ARCHITECTURAL REVIEW BOARD STAFF REPORT

Project #/Name	ARB-2022-58: Scruby Verizon	
Review Type	Advisory Review - Tier 3 PWSF	
Parcel Identification	05500-00-00-01400	
Location	7418 Greenwood Station Road	
Zoned	Rural Area (RA) / Entrance Corridor (EC)	
Owner/Applicant	Brian Gray Scruby / GDN Sites (Nathan Holland)	
Magisterial District	White Hall	
Proposal	To construct a telecommunications facility consisting of a 140'-tall monopole topped by a 2'-tall lightning rod, with associated structures and equipment. The proposal includes a request for a Special Exception regarding the distance between the face of the monopole and the backs of the antennas.	
Context	The subject parcel is nearly 45 acres in size and is bisected by I-64. The portion of the parcel located south of the in where the monopole is proposed, has wooded borders on the north, east and west, and some hedgerows and scatter in the eastern half. Most of the property is occupied by open fields. The surrounding area is rural in character with reand agricultural buildings, many of which are historic. (Fig. 1)

ARB Meeting Date	July 18, 2022	
Staff Contact	Margaret Maliszewski

Fig. 8: Applicant's detail showing 18" from face of monopole to back of antenna.

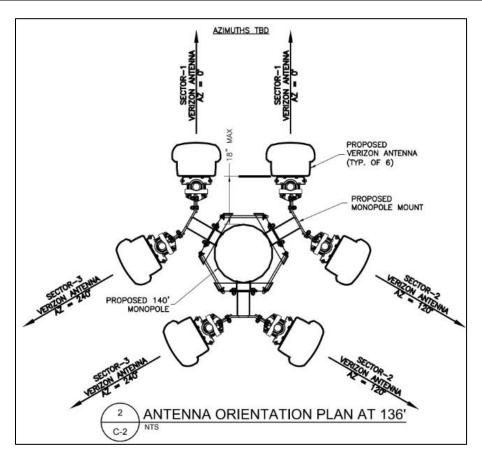
Request	Applicant's Reasoning	Staff Comment
Request to allow the closest point of the	The applicant states that the proposed mounts will not	Staff agrees that a consistent 18" standoff will
backs of the mounted antennas to be 18"	allow the antennas to meet the 12" requirement.	not create significant additional negative visual
from the face of the monopole. 12" is the	Internal electric tilting (not physical tilting) of the	impact as viewed from the I64 EC.
standard requirement. 5.1.40.b(2)(c)	antenna is proposed, with a consistent 18" standoff for	
	the full length of the antennas.

1. The ARB finds that a consistent 18" standoff will not create significant additional negative visual impact as viewed from the I64 EC.
